December 2, 2016

SUBJECT: **Modification Request of Section 404 Regional General Permit No. 31 and Section 401 General Water Quality Certification No. 3886** for the proposed Interstate 85 (I-85) Widening and Interchange Improvements from north of NC 73 (Davidson Highway / Exit 55) to north of SR 2180 (Lane Street/Exit 63), Cabarrus & Rowan Counties, Divisions 9 and 10. Federal Aid Project No. FANHIMF-085-2(61)55, TIP Project No. I-3802A.

PERMIT DRAWING
SHEET 36 OF 128

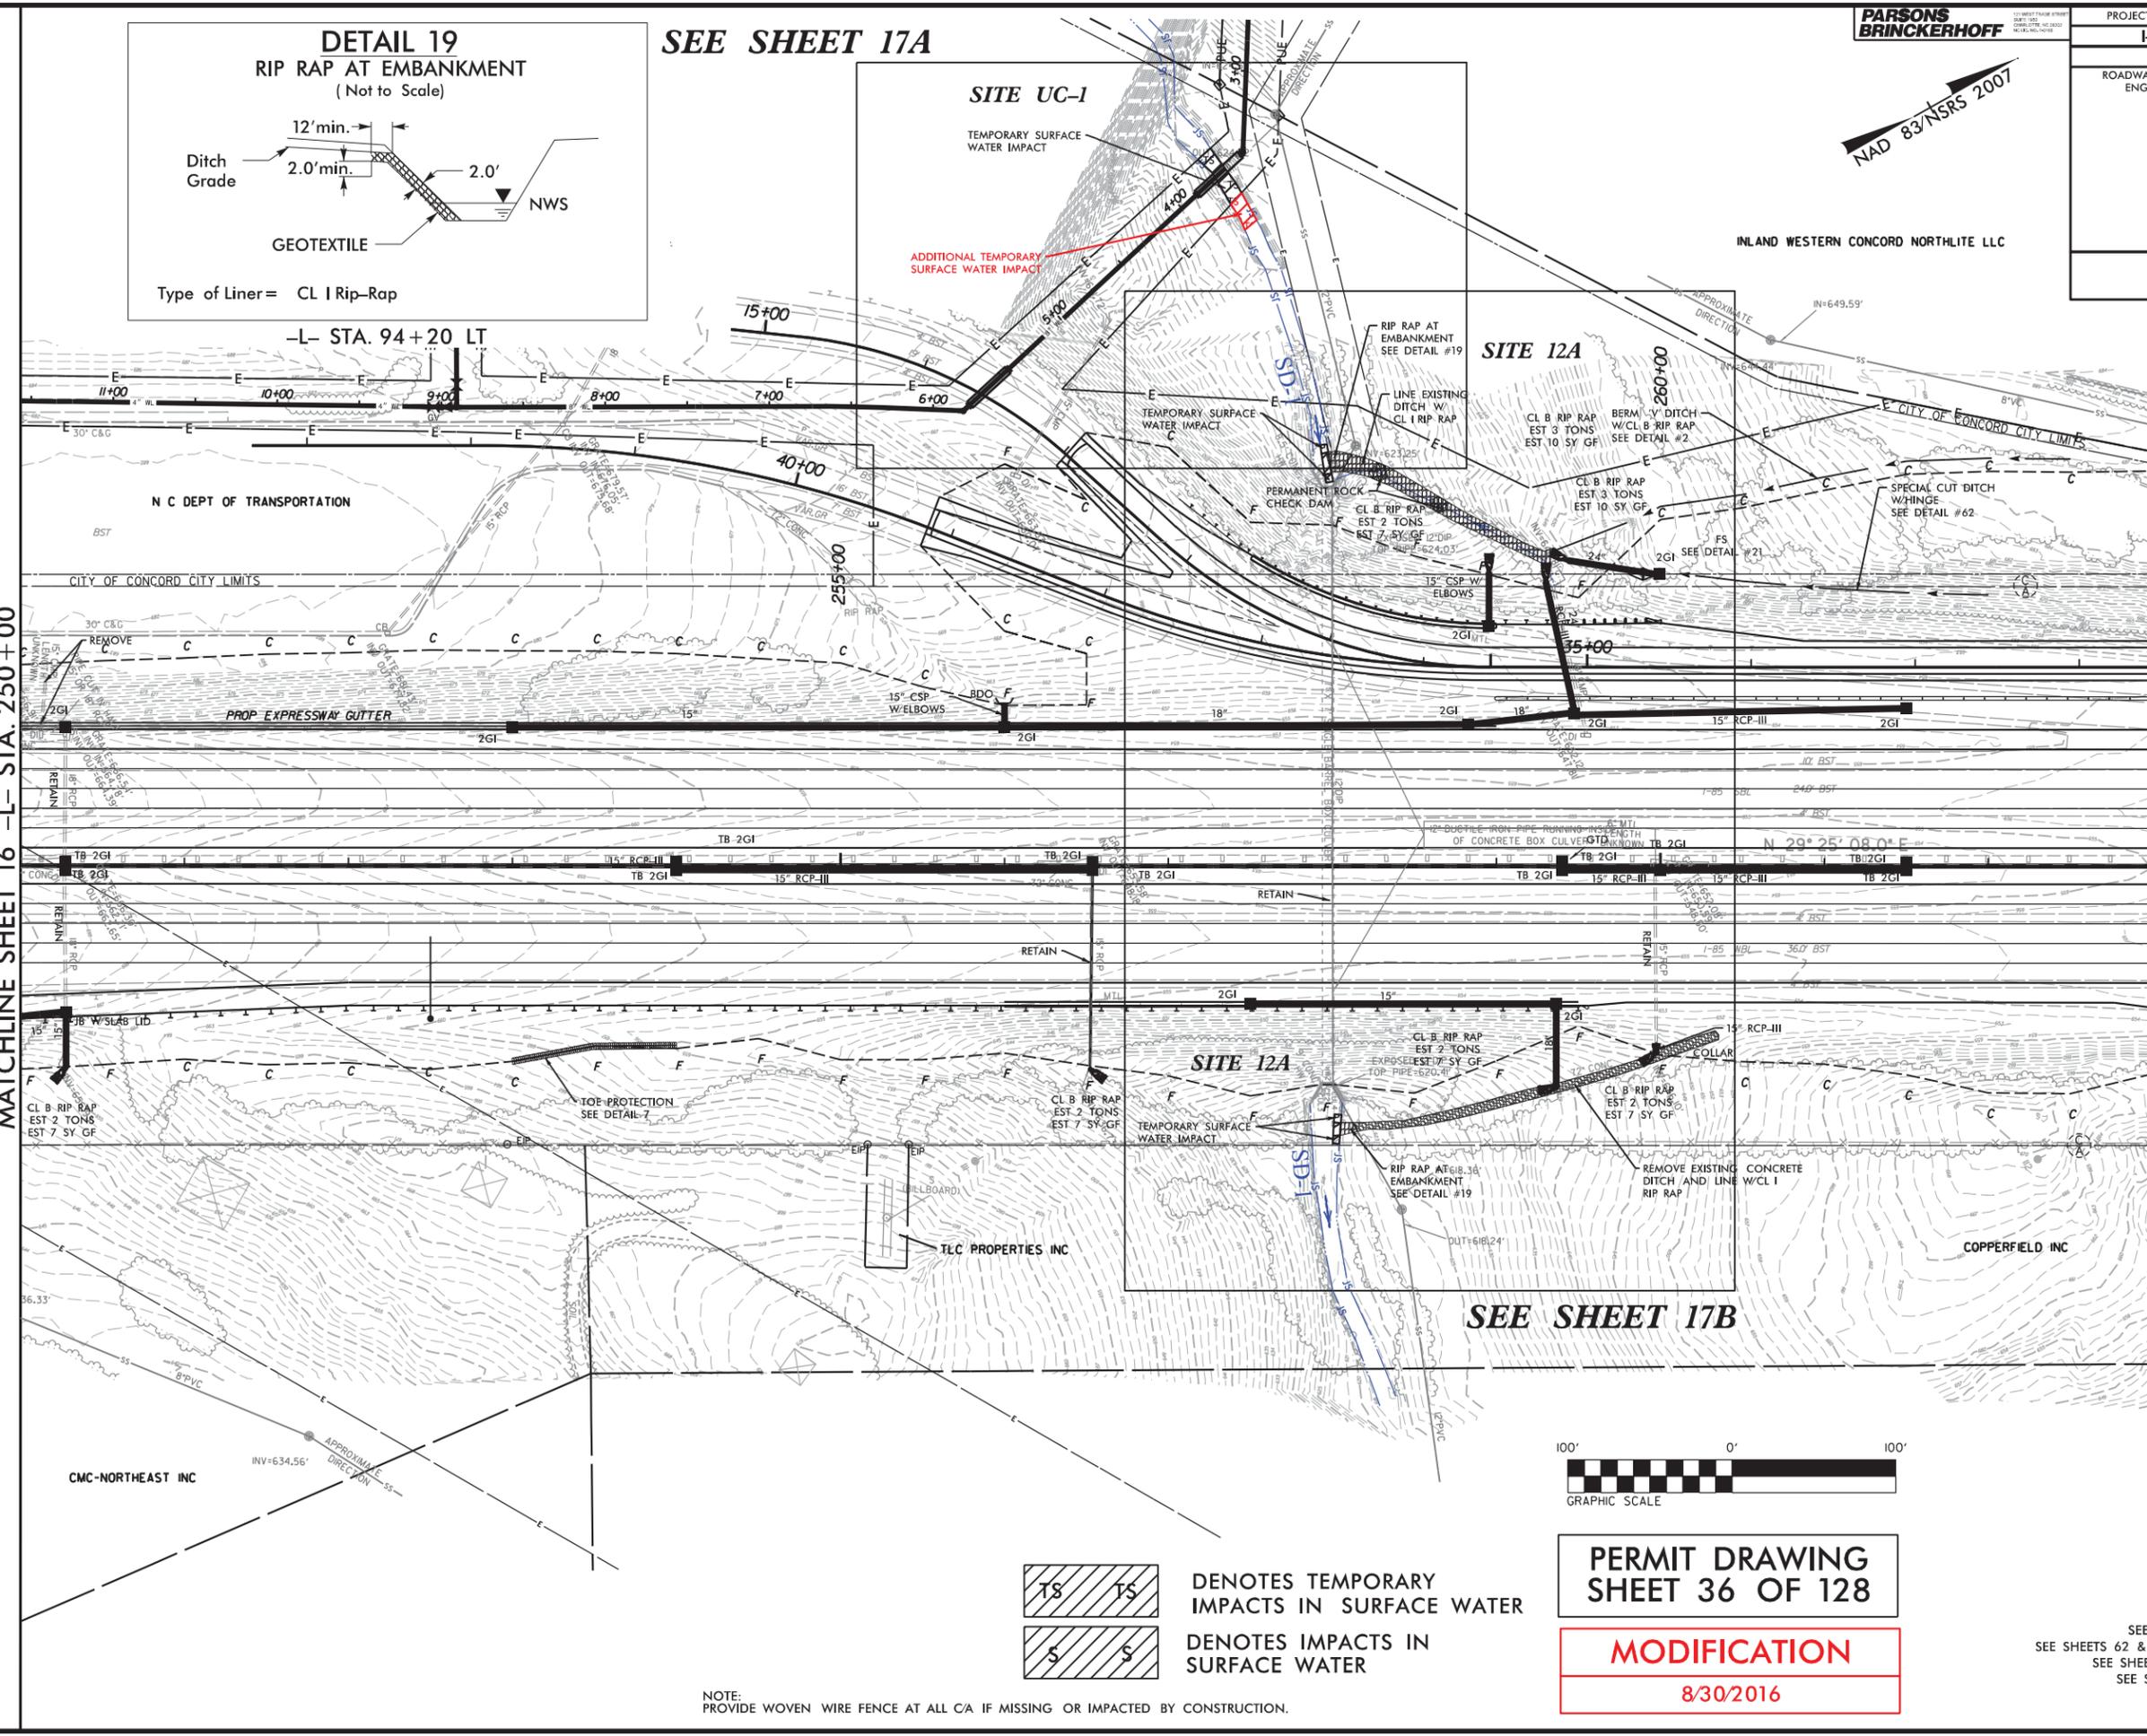
On July 19, 2016, representatives from NCDOT met on site with Ms. Donna Hood to conduct a project review. During the site meeting Ms. Hood measured additional unpermitted temporary impacts of approximately 16 feet in length to Site UC-1. During the site prep for the installation of the proposed waterline, additional areas were cleared along the stream banks. The clearing impacts were necessary for the installation of the waterline and to allow for a dry work area. Ms. Hood recommended that these additional impacts be included in the next permit modification. Ms. Hood contacted Ms. Crystal Amschler (USACE) via email on September 21, 2016 to inform her that she had observed the aforementioned impacts and had made recommendations to the contractor regarding a time frame for submission of the modification request.

The temporary surface water impacts associated with the waterline installation overrun resulted in an additional 19 linear feet of temporary stream impact per the contractor's field measurements (this is the same area as the 16 feet referenced above, but a more

accurate measurement). The proposed impact total for Site UC-1, including the previously-permitted impacts and the currently unpermitted impacts are 56 linear feet of temporary stream impacts. No other changes to permitted wetland and stream impacts are proposed for Site UC-1.
